# Sonoma County Planning Commission **STAFF REPORT**

**FILE:** DRH16-0006  
**DATE:** August 3, 2017  
**TIME:** 1:30 PM  
**STAFF:** Georgia McDaniel, Project Planner

**Appellant:** Valley of the Moon Alliance (VOTMA)  
**Applicant:** Flora Li for Tohigh Investment  
**Owner:** Tohigh Investment SF LLC (Tohigh)  
**Location:** 900, 1200, 1202, and 1204 Campagna Lane, Kenwood  
APNs: 051-260-014 Supervisorial District No.: 1  
**Subject:** Appeal of Design Review approval for a new Inn, Spa, and Restaurant  
**PROPOSAL:** Request for final Design Review approval for an inn, spa, and restaurant on a 51.9 acre parcel.

Uphold the October 19, 2016 Design Review Committee approval of the revised project design and site plan modifications with two minor changes required by the Open Space Conservation Easement.

**A**  
10  
**AREA OF SUPPORT BLDG - CONCEPTUAL PLAN**  
SCALE: 1" = 30'

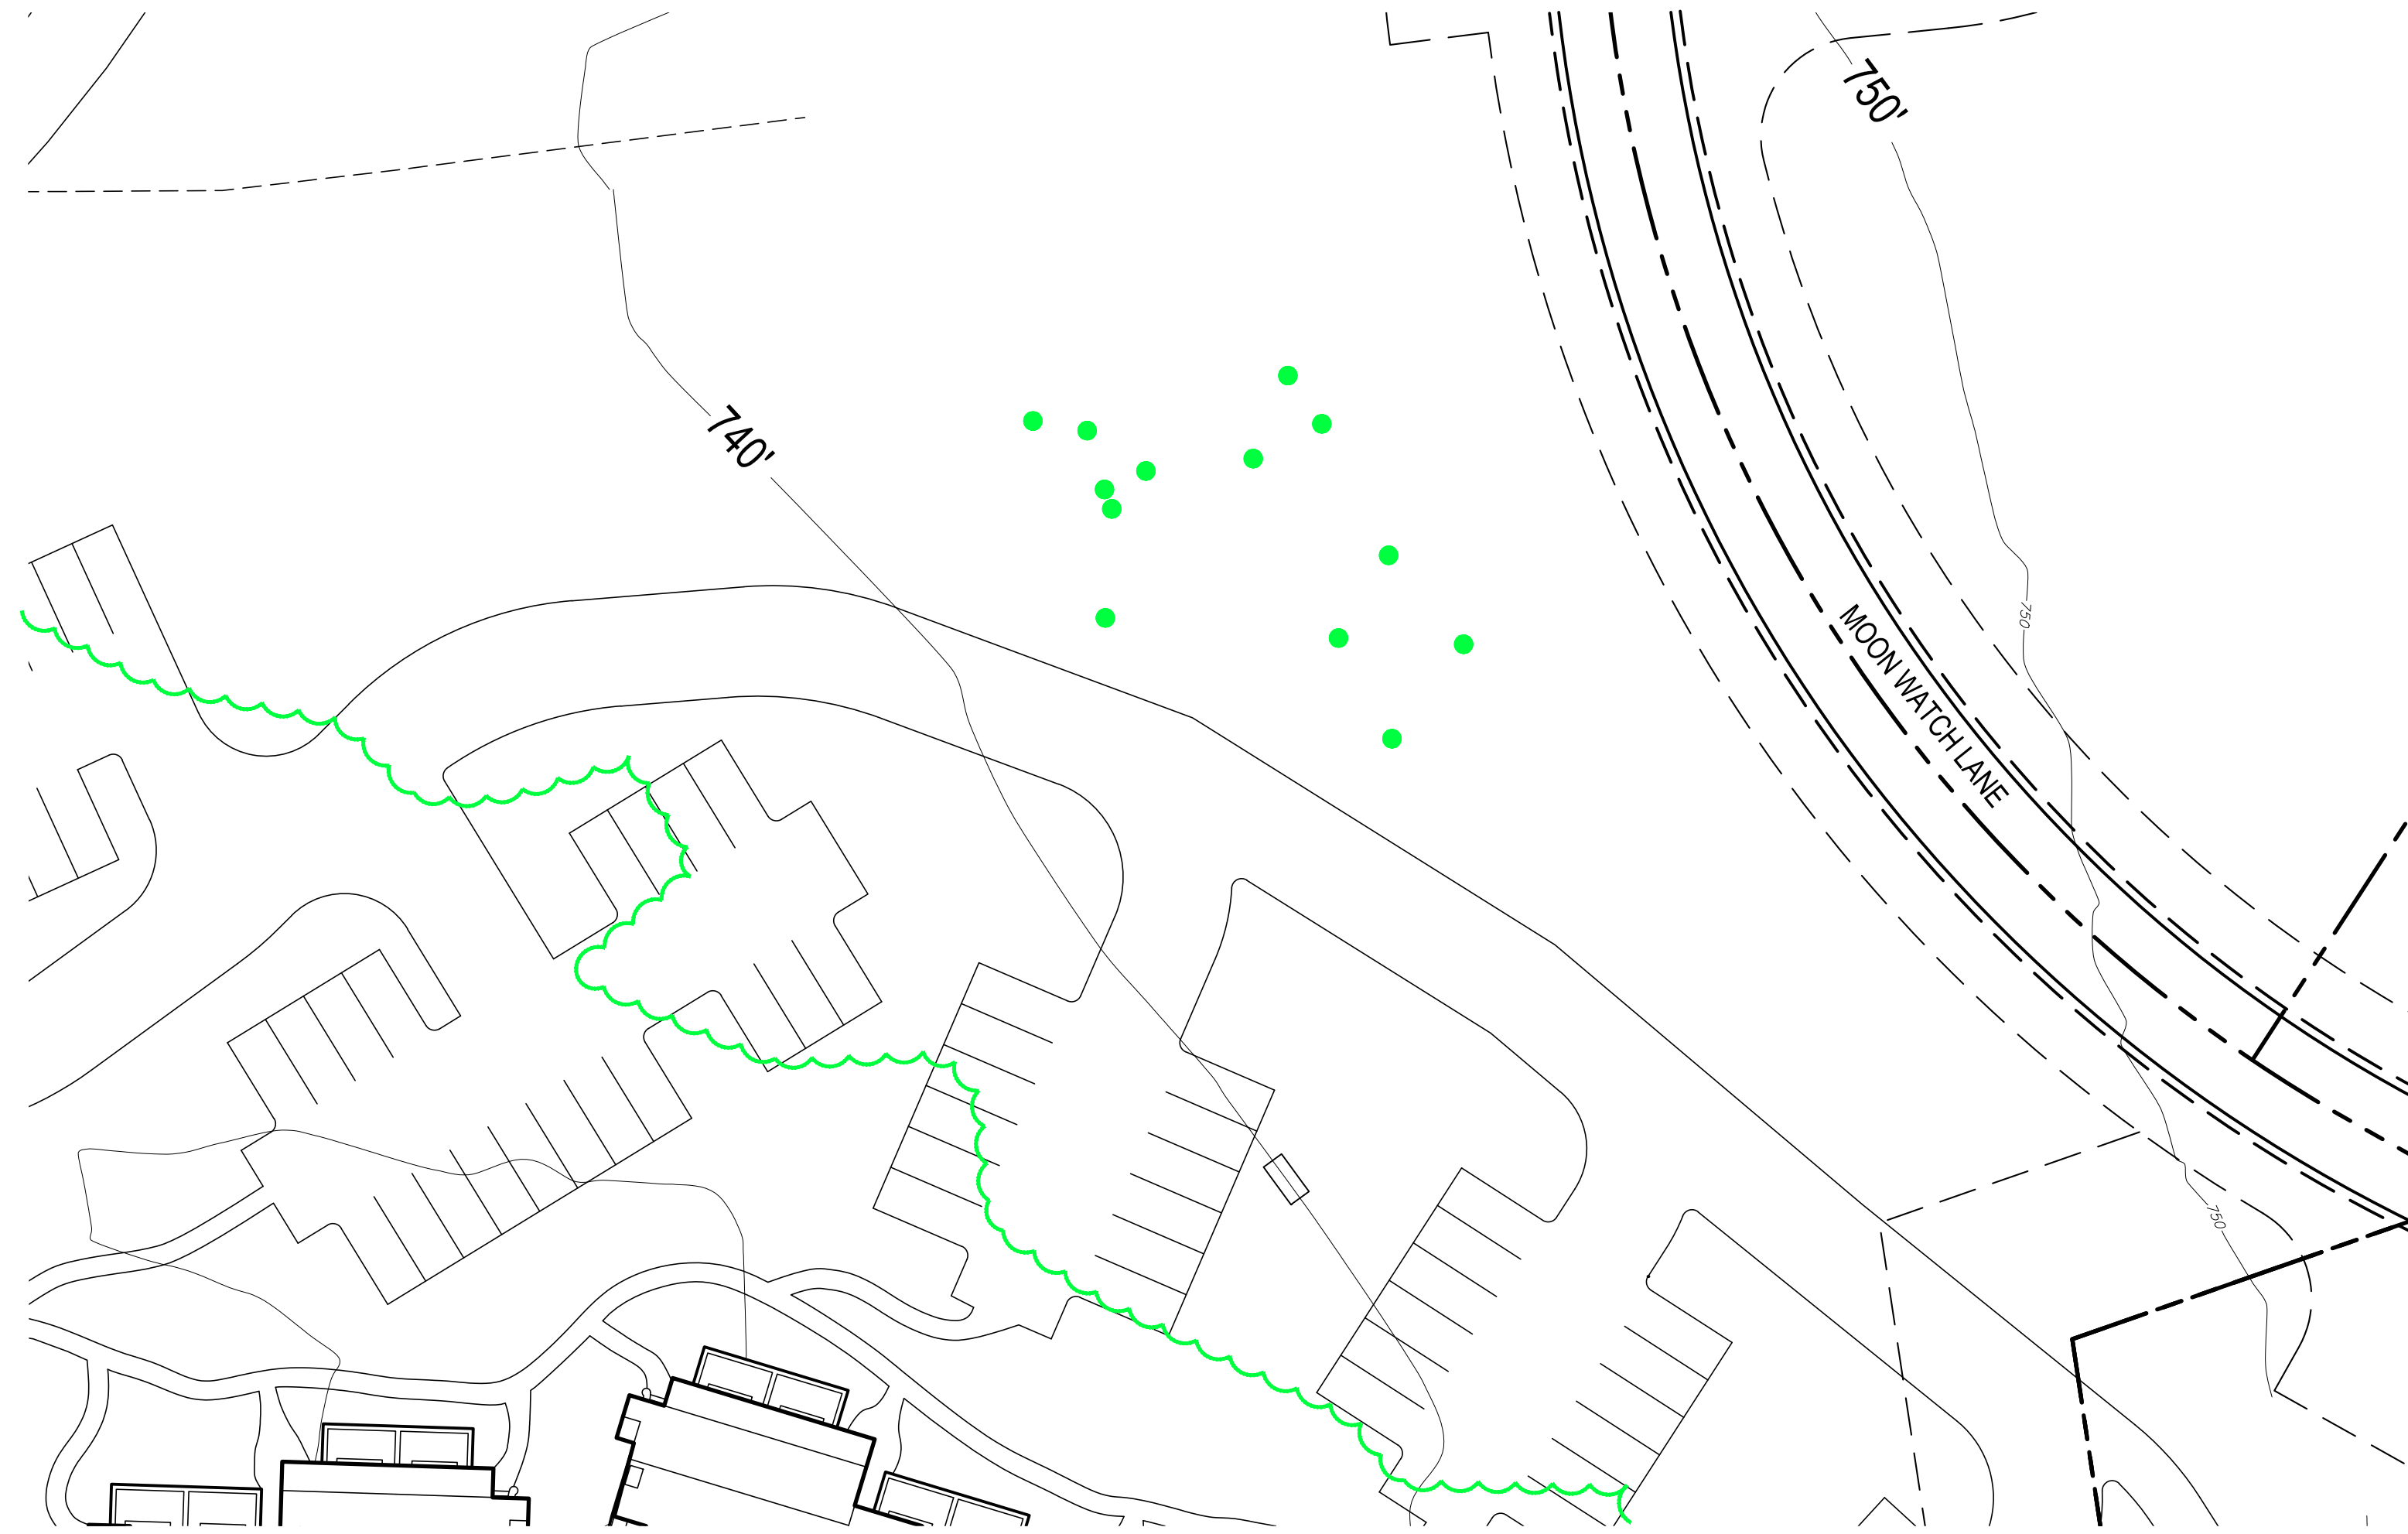
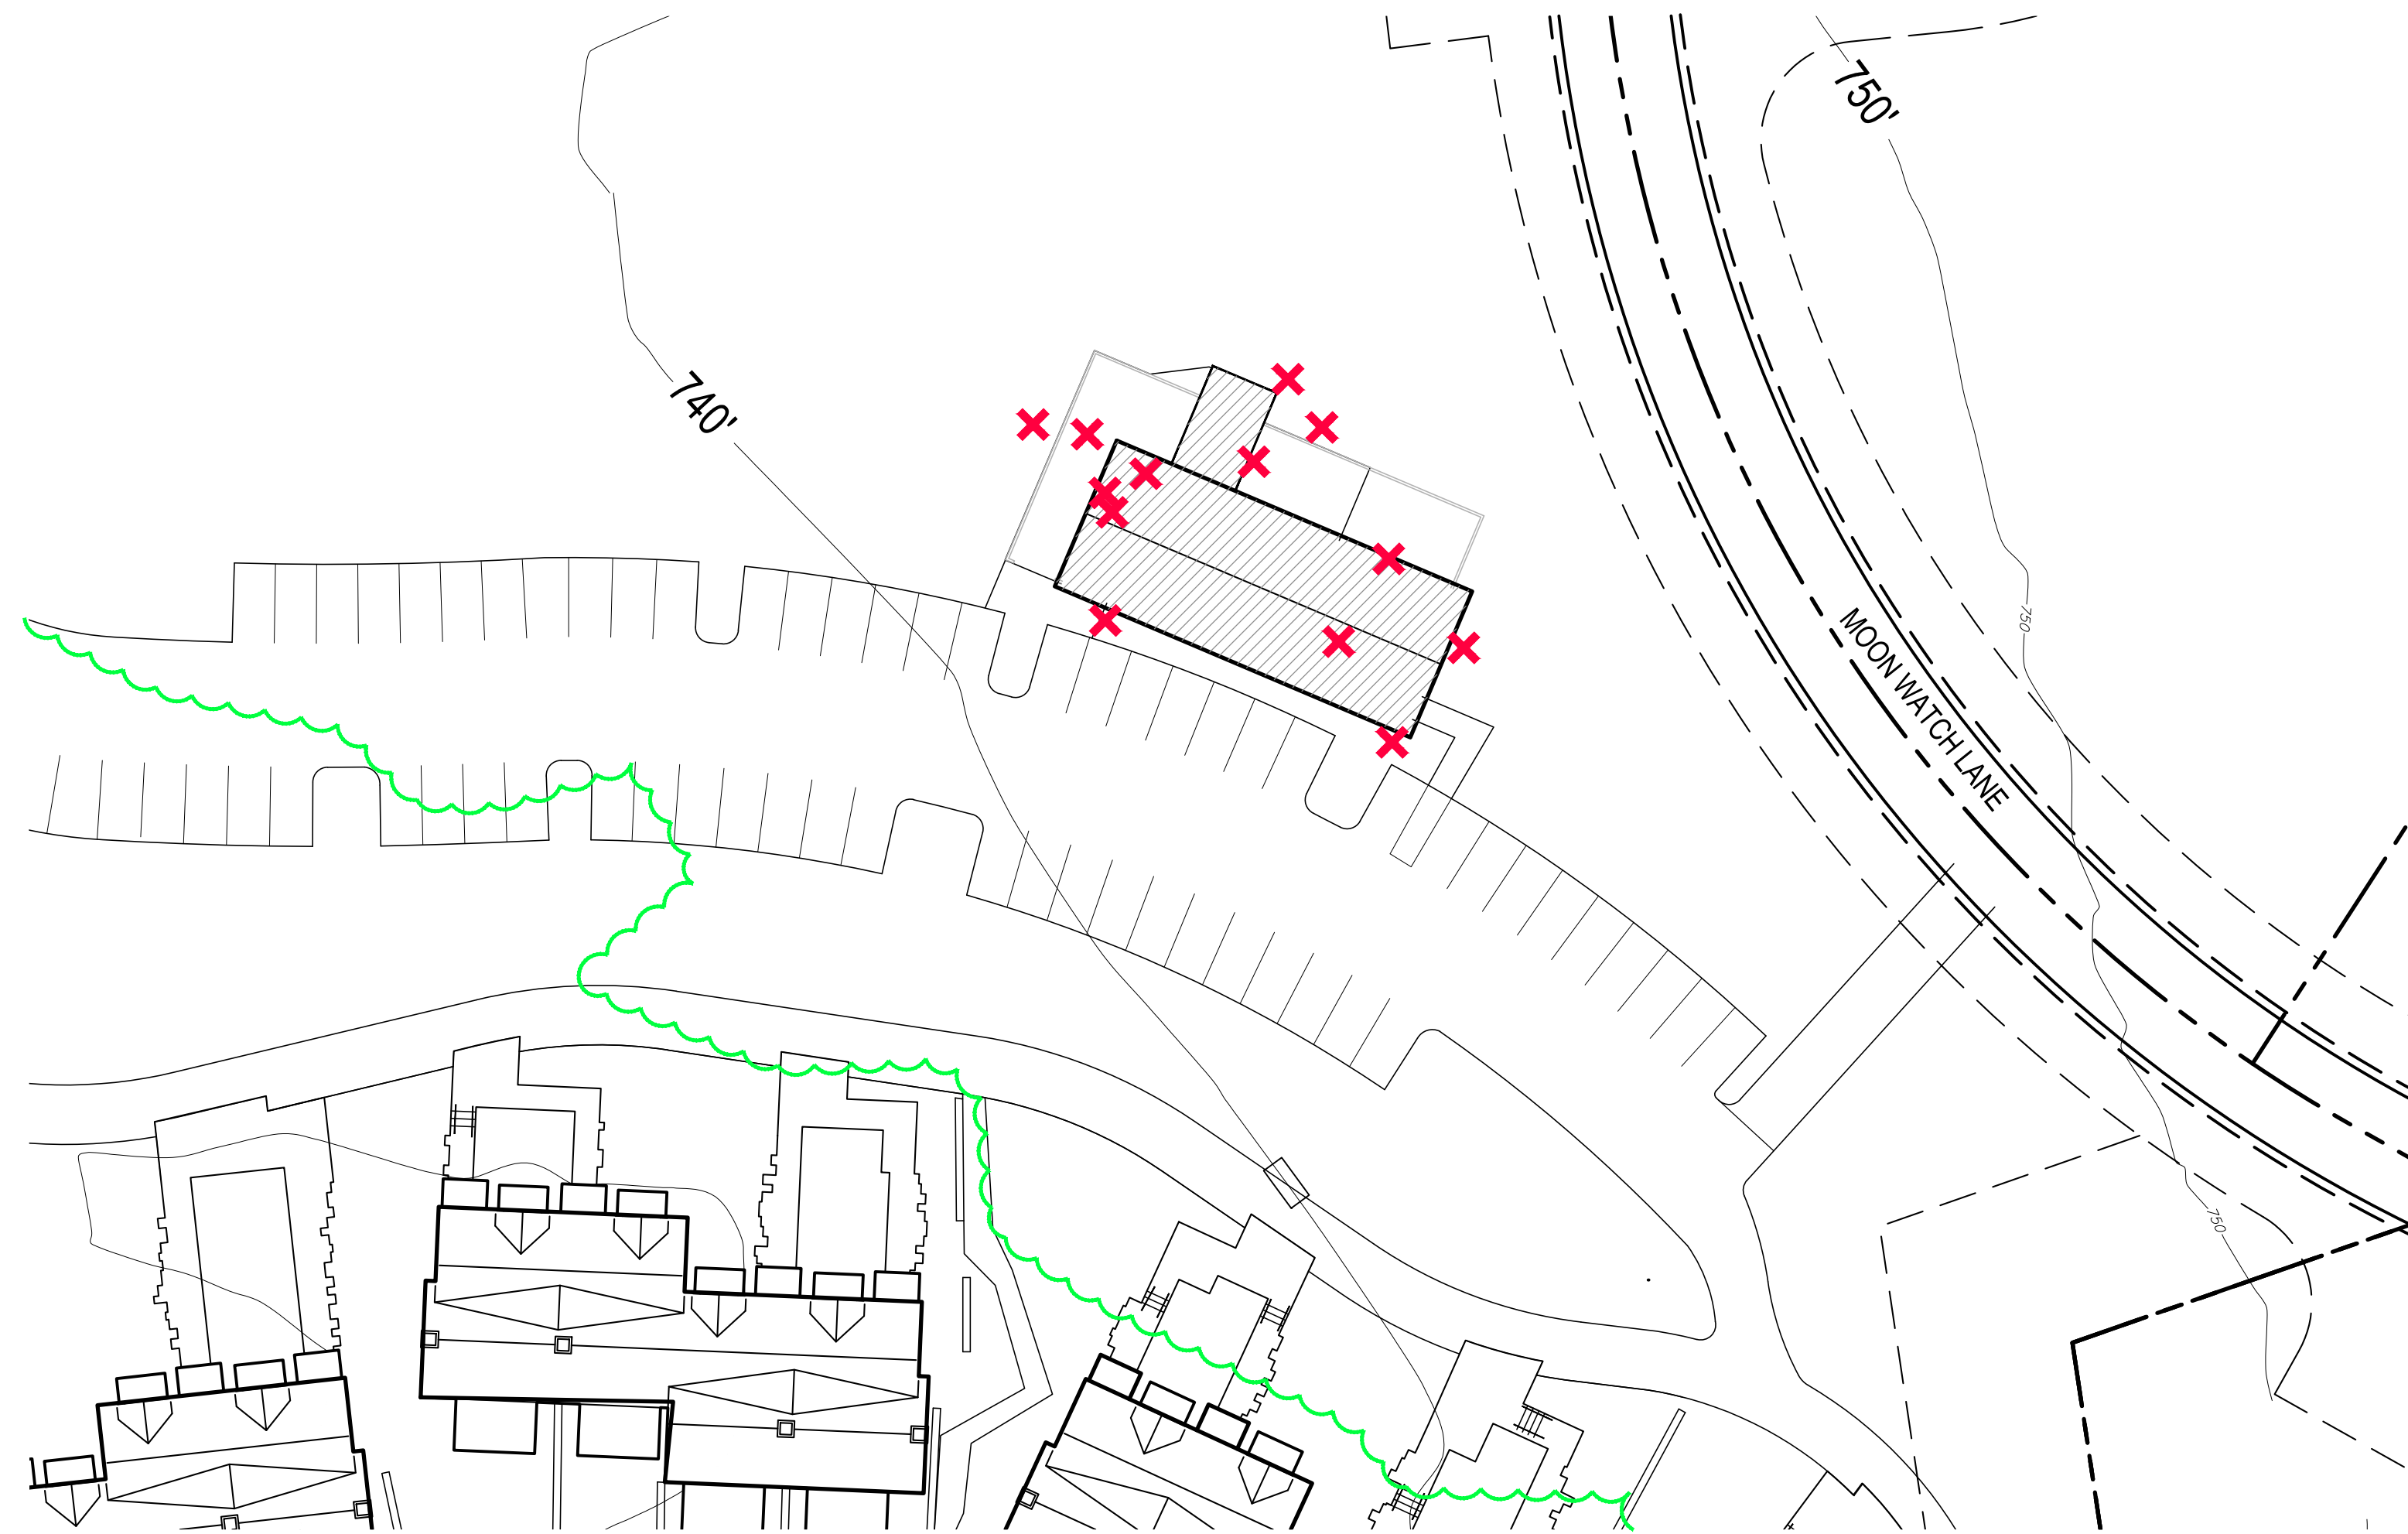
Staff confirmed in response to an inquiry from DRC member Wurtz that the "support building" located to the northeast edge of the site beyond the new valet parking lot was not included on the Exhibit 3.0-10 layout. The applicant has provided little information about the function, size, and facility capability (water, electrical, sewage disposal etc) of the building. Slides X1-X5 of the 10/04/16 design plans show that it has five windows, an enclosed yard, a generator enclosure and a space for parking and charging 4 electric carts.

The new support building would be moved from square footage within the main inn building to a location next to the planned circulation path of the eastern parking lot. This would minimize any impervious coverage or tree removal for additional circulation routes. There would not be an increase in square footage. The square footage would just be relocated. See Sheet 11 of the BGK Summary for design drawing comparisons and additional information regarding the support building.
